LIGHTS BEACH DEVELOPMENT CONCEPT PLAN
DRAFT ONLY

LIGHTS BEACH REDEVELOPMENT concept plan

SCHEDULE OF SUBMISSIONS

‘Lights Beach Concept Plan’

03 CONCEPT PLAN
 1:500 (A3)

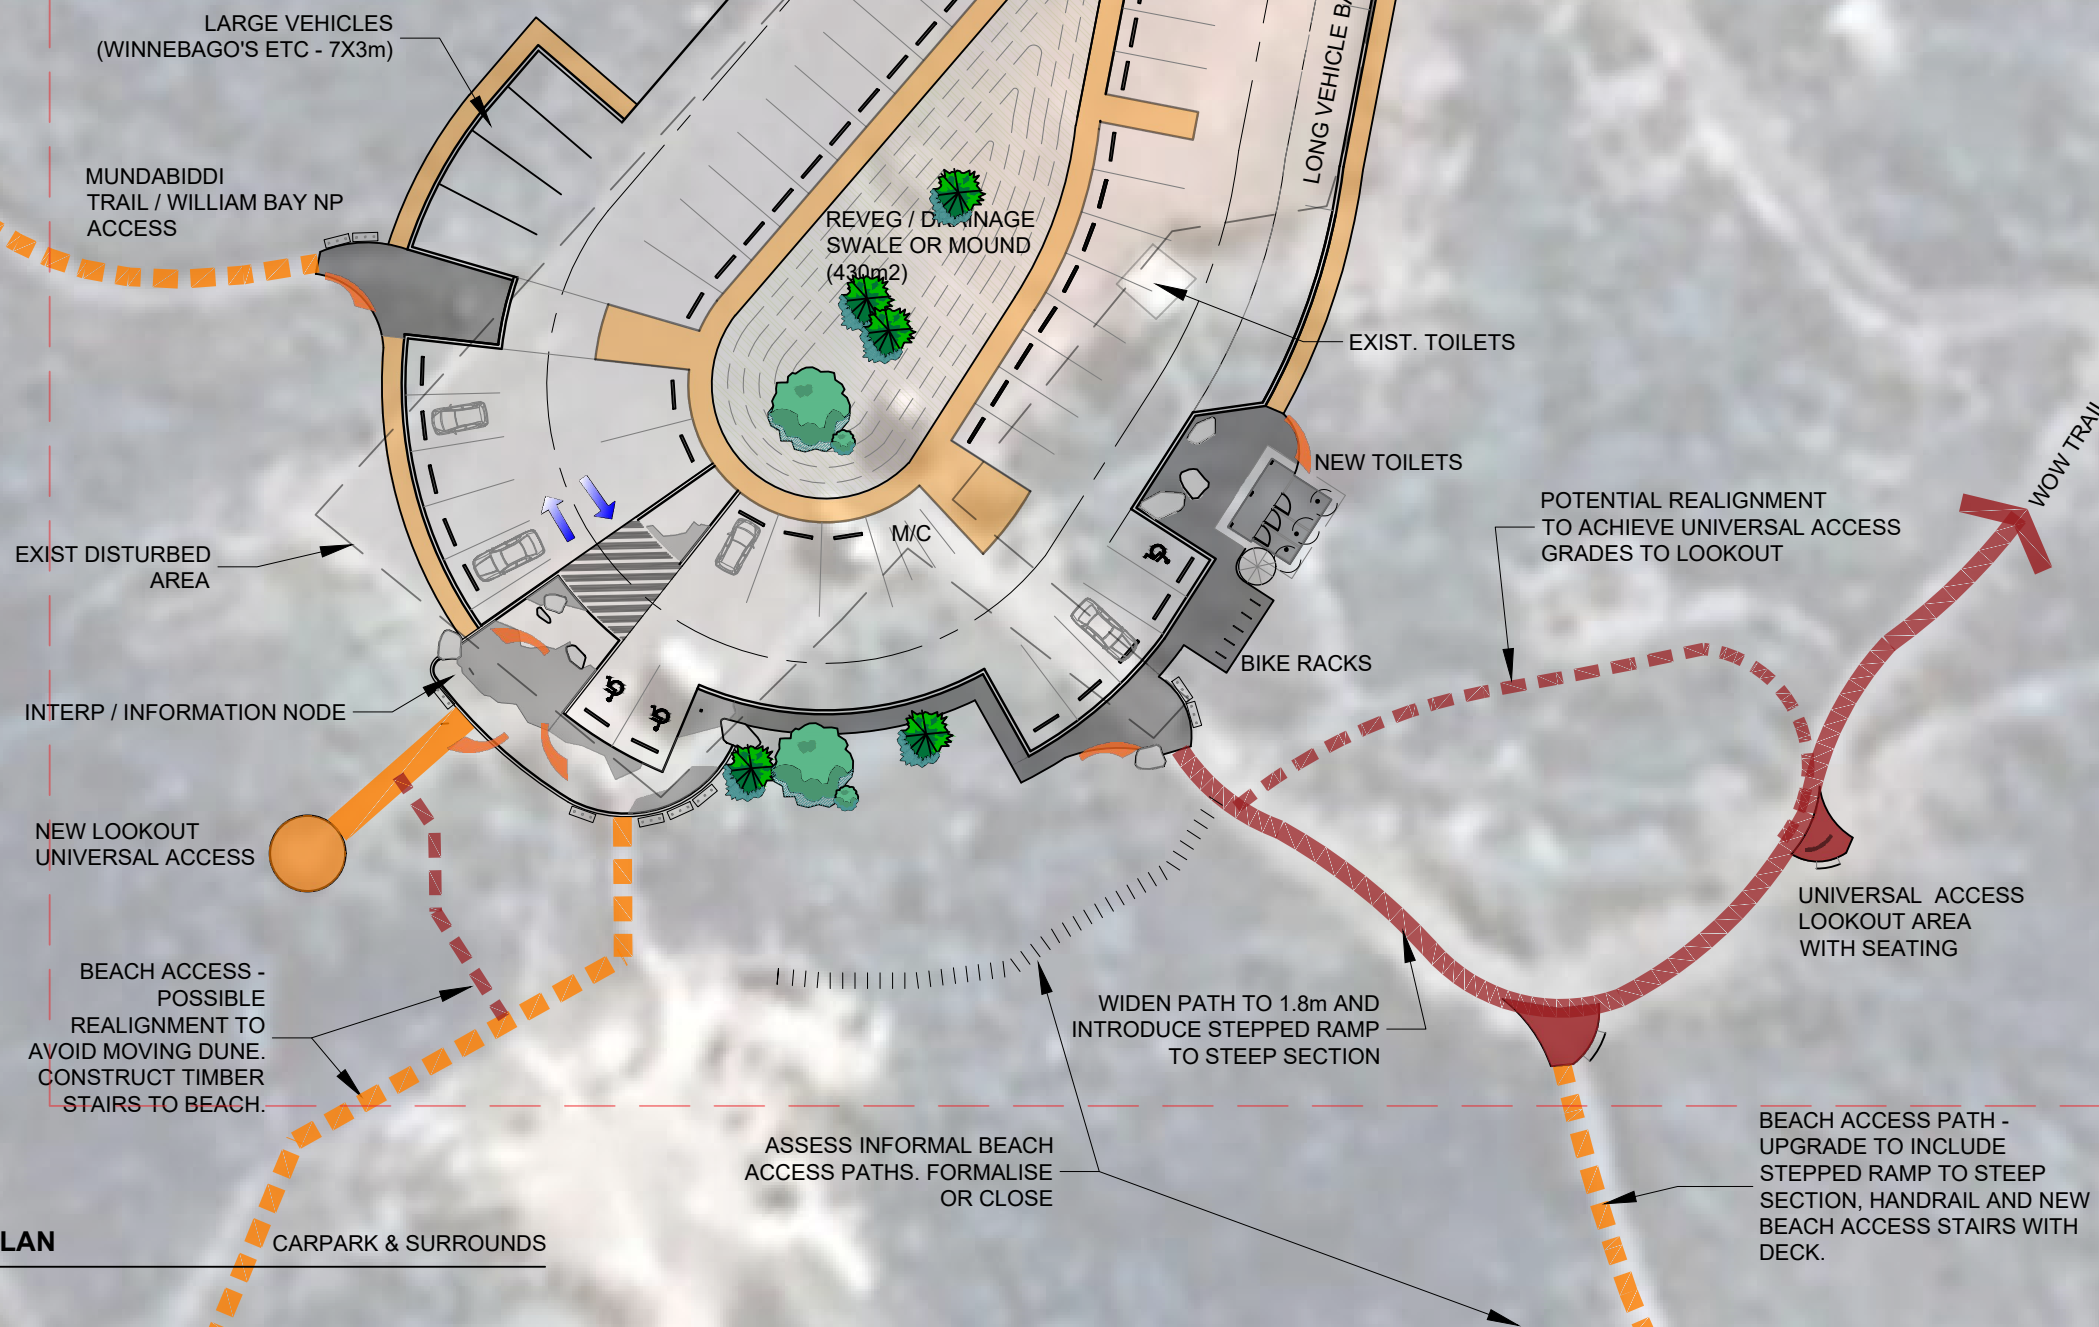
<p>11 LongVehicleParking-vegetation will need to be cleared. Banks will need stablising or degree of slope lessened by clearing further. Car-Park- Where is the need for so many parking bays? Utilise existing cleared area for parking. Lookout- No need to change existing lookout, already functional. Platform at base of steps unnecessary, will impact on natural features(granite rock). Sand will shift and step down to sand will always change. Where is money for this project coming from? To use Drought Assistance funding would not be aoproppiate.</p>
Denmark Weed Action Group	<p>12 CAR-PARK- Use already cleared area for parking. Long vehicle parking will impact native vegetation. Is there a need for so many parking bays? LOOKOUT- No need for new lookout, existing one is functional. Keep signage to a minimum. PLATFORM at base of steps will have no advantage over what is already there. It will detract from the natural beauty of the granite rocks. The sand will always shift and there will never be a consistent height to step down from. FUNDING- To use Drought Relief funds would be inapropriate.</p>

<p>16 1. Sacrifice two bays each row to form planted islands PI1 & PI2 otherwise it is a long unbroken area/row of bays. 2. Secondary path to beach - surfers view point. Form into a path otherwise they will degrade this overland route. 3. Make up bays at the entry if necessary.</p>
